Safety Evaluation Report

Related to the License Renewal of Prairie Island Nuclear Generating Plant Units 1 and 2

Docket Nos. 50-282 and 50-306

Northern States Power Company, a Minnesota Corporation (NSPM)

Figure 4.3-1

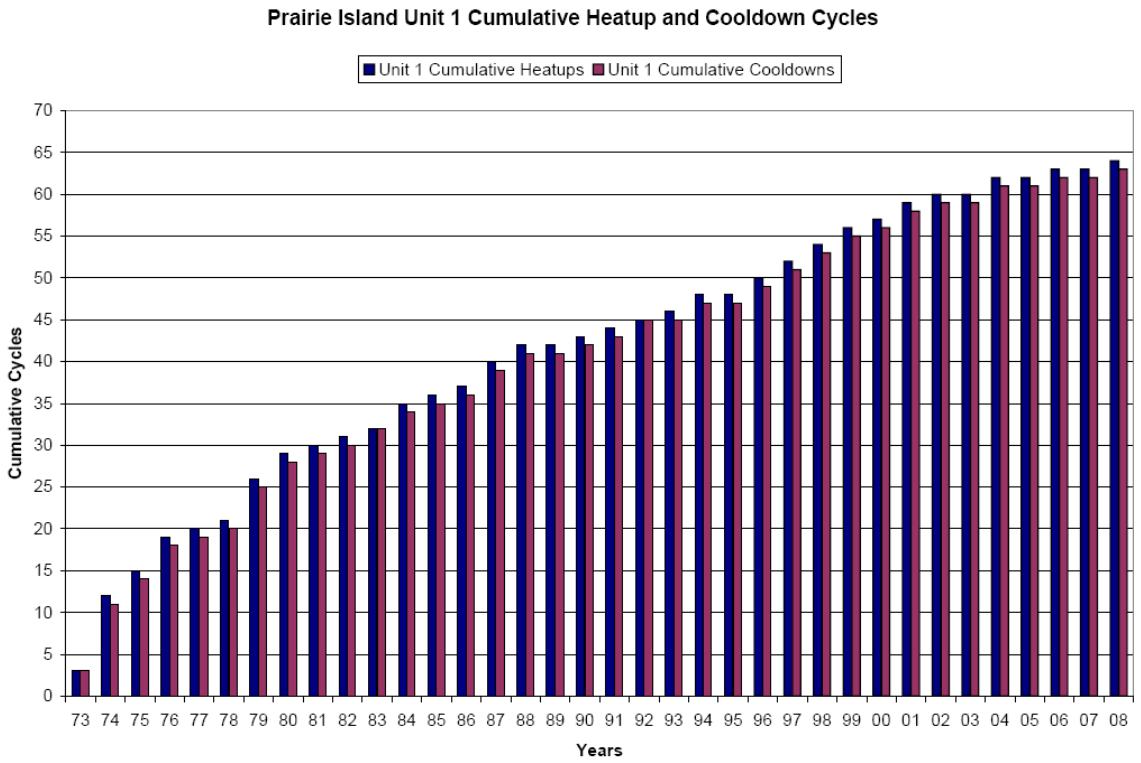
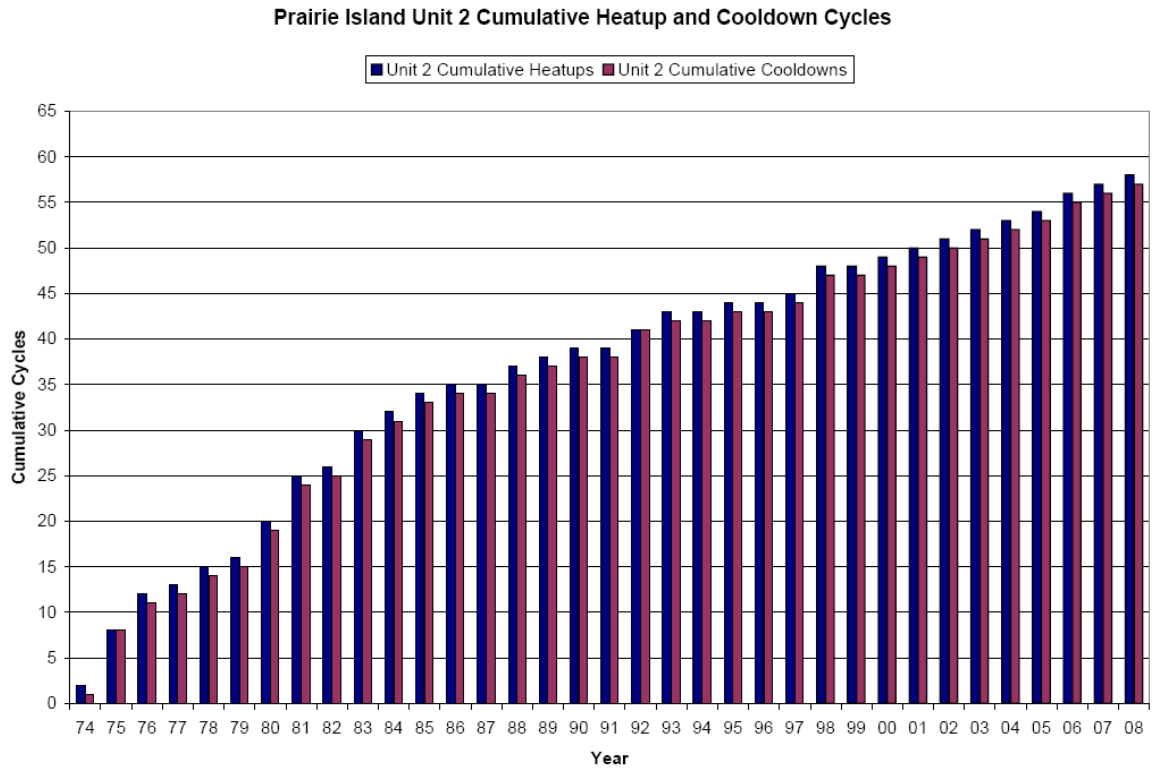
The staff reviewed these histograms and found that the transient occurrence rates (both heatup and cooldown) are quite constant for Unit 1 since 1980 and for Unit 2 since 1983. This means that for the past 25 years, the PINGP (Units 1 and 2) plant operation has been quite steady. The applicant made its cycle projections by doubling the actual number of cycles accrued as of September 30, 2006, using the maximum from either unit. The staff notes that cycle projection can be graphically represented, based on Figure 4.3-1 by drawing a straight line from the intersection of the x and y axes to the 2003 data point, boosted to the cycle value accrued by September 30, 2006, using the maximum from either unit. It is clear from Figures 4.3-1 and 4.3-2, that the slope used by the applicant for making cycle projections is significantly greater than that of the average of the past 25 years. As expected, the slopes of event occurrence (i.e., the rates) during the first few years (5 to 7 years) are higher than the averages for both heatups and cooldowns. This means that the basis of projections that the applicant used is conservative and therefore, the staff found it to be acceptable.

Based on its review, the staff’s concern on the transient event monitoring is resolved because the applicant provided the information requested and the information validates the PINGP fatigue management program and the applicant's assumption for the number and severity of transients.
